**PROJECT**  
204 - 232 KING STREET  
204 - 232 KING STREET  
MELBOURNE VIC 3000

## DELEGATE REPORT MINISTERIAL PLANNING REFERRAL

Planning Permit TP-2020-33 was issued by the City of Melbourne on 31 July 2020 for demolition of existing buildings (with the exception of the street walls of 204-208 King Street) and construction of a multi-storey mixed-use development.

The current proposed amendment to Permit (TP-2020-33) results in an increase in GFA above 25,000 m<sup>2</sup>. As such, the Minister for Planning is the responsible authority.

Figure 20: Proposed development (Typical Tower)

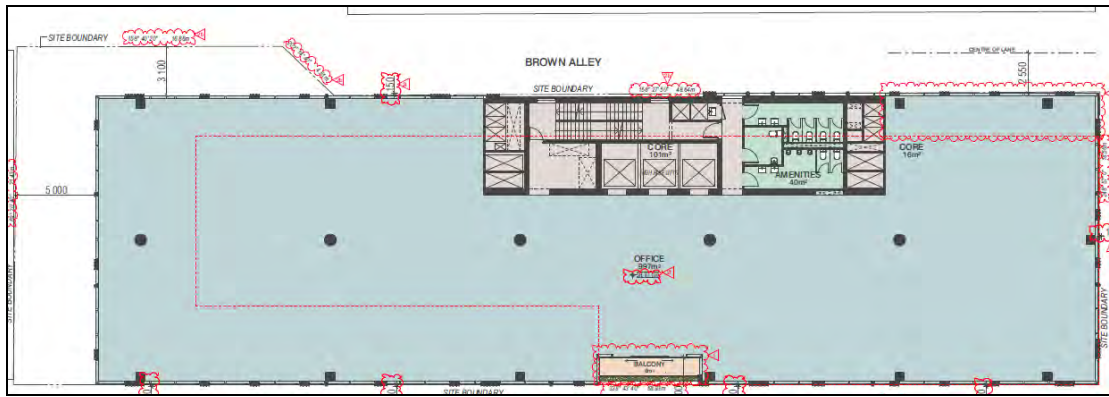
The approved development provides a 5 m setback above 40 m at the northern portion of the west (King Street) elevation. As depicted in Figure 20, the amendment seeks to extend the street wall up for its full height (80 m) with a zero setback.

The new 80 m high street wall extends for 63.7 m, which is greater than the discretionary 25 m. As described at Section 6.2 of this report, the applicant has submitted an informal set of plans and visualisations (30.11.2021) that incorporates 9.51 m wide centrally-located balconies that, along with material variation, acts as a break in the façade. In addition, the 1.7 m deep landscaped recesses at Levels 11 and 12 further breaks up the wall, along with use of solid materials to carry through the typical parapet height at a human scale. The breaking-up of massing along King Street is depicted in the applicant's "fly-through", captured at Figure 32. While the extended tall street wall is a variation to the preferred modified requirement, if the above-mentioned changes were formally introduced along with minimum 2 m deep balconies (increased from 1.7 m), it is recognised that in this particular instance the proposal would have adequate regard for the width of King Street; maintain a human scale at lower levels; maintain adequate opportunity for daylight, sunlight and sky views in the street; and deliver a strong defining corner building without unduly impacting on the amenity of public spaces.

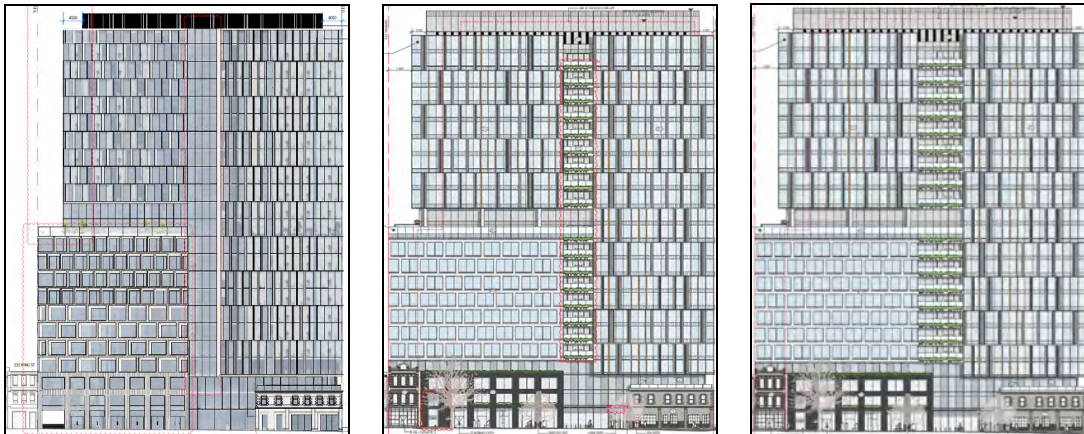
- Overwhelming horizontal bulk of tower to King Street and Brown Alley frontages.

Urban Design continues to have concerns with the unbroken horizontal bulk of tower frontages to King Street and Brown Alley. Acknowledging that a vertical recess corresponding to a small balcony has been incorporated to King Street, it is recommended that the proportions of this balcony are increased substantially.

In response, the applicant has submitted various informal iterations of plans. The latest set of plans dated 30.11.2021 provides a 3.17 m increase to the width of the centrally-located balconies on King Street (total width = 9.51 m). A comparison between the approved, assessment and latest informal King Street elevation drawings is shown in Figures 25–27.

Figure 34: Informal Typical Tower floor plan 30.11.2021

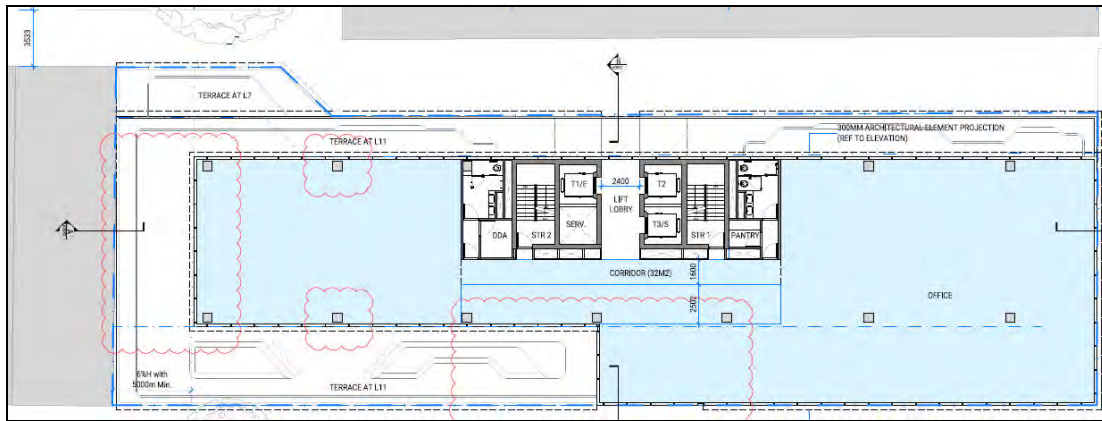
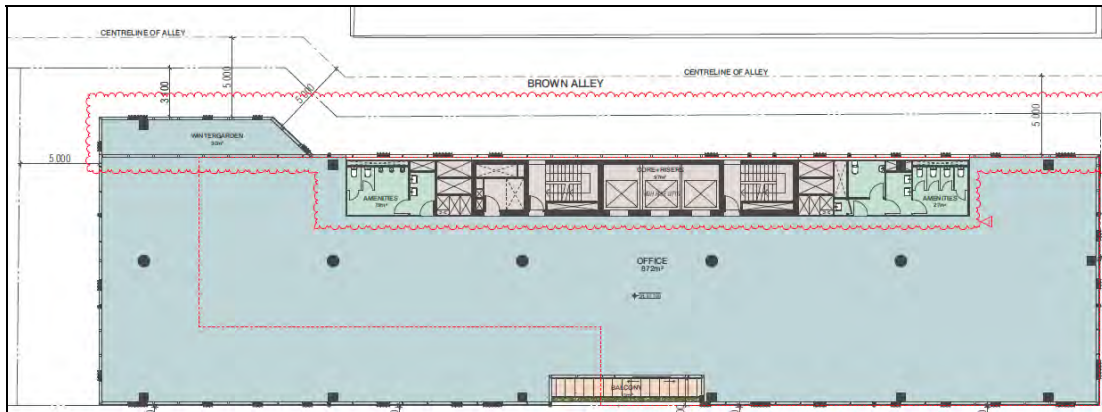
In response, an informal set of plans submitted by the applicant, dated 30.11.2021, provides a 5 m setback from the centreline of Brown Alley above 40 m. The changes result in a 40 m high podium and a recessive upper form to an overall height of 80 m.

Importantly, the revised setback remains within the building envelope approved under the original permit (towards the southern portion of the site) and is therefore accepted.

Towards the northern portion of the site, the eastern elevation proposes to follow the 'kink' in the east boundary – as demonstrated in the comparison floor plans in Figures 33 and 34. A 5 m set back is maintained from the centreline of the laneway.

Figure 36: Proposed North Elevation

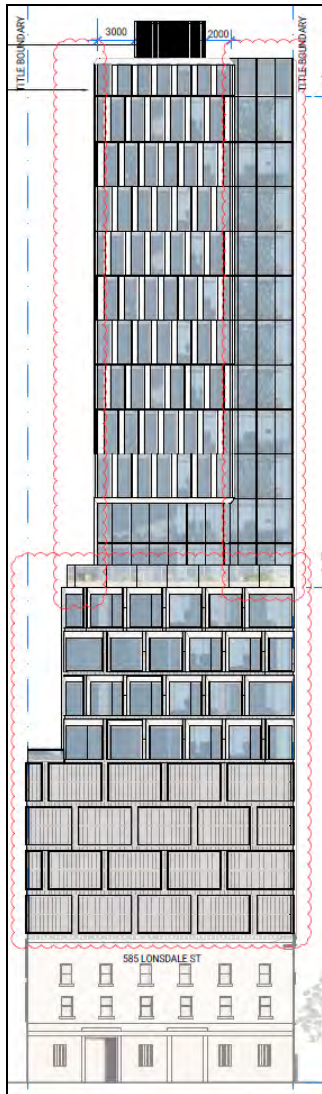
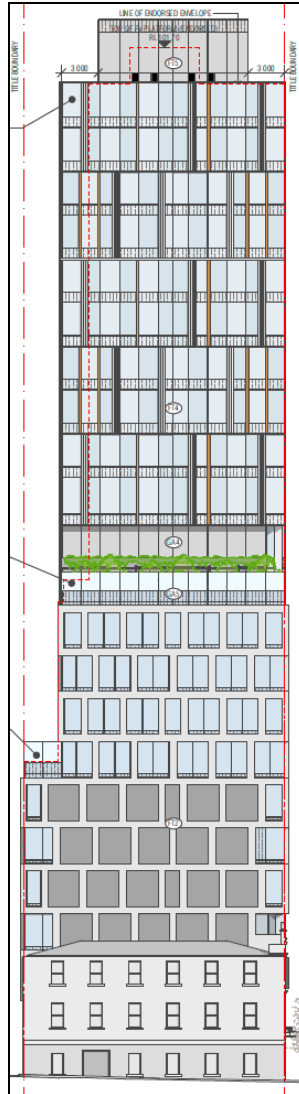
As outlined at Section 6.1 of this report, the Colonial Hotel is a significant-graded building and consideration must be given to the proposed development's north side elevation and the visual impacts associated with an 80 m high wall.

The changes to the north elevation between the approved and proposed developments, as viewed from the north, are somewhat limited. While the podium would now be sited on the shared boundary (instead of 6.2 m separation in the approved scheme), and the tower would now be set back 5 m from the boundary (instead of 11.2 m in the approved scheme), an 80 m high building will continue to serve as a backdrop to the Colonial Hotel. The proposed northern elevation will also be wider than the approved; however, this is managed through a high level of articulation and a 6.5 m deep landscaped recess at Levels 11 and 12. A comparison between the approved and proposed north elevations is below (Figures 35 & 36).
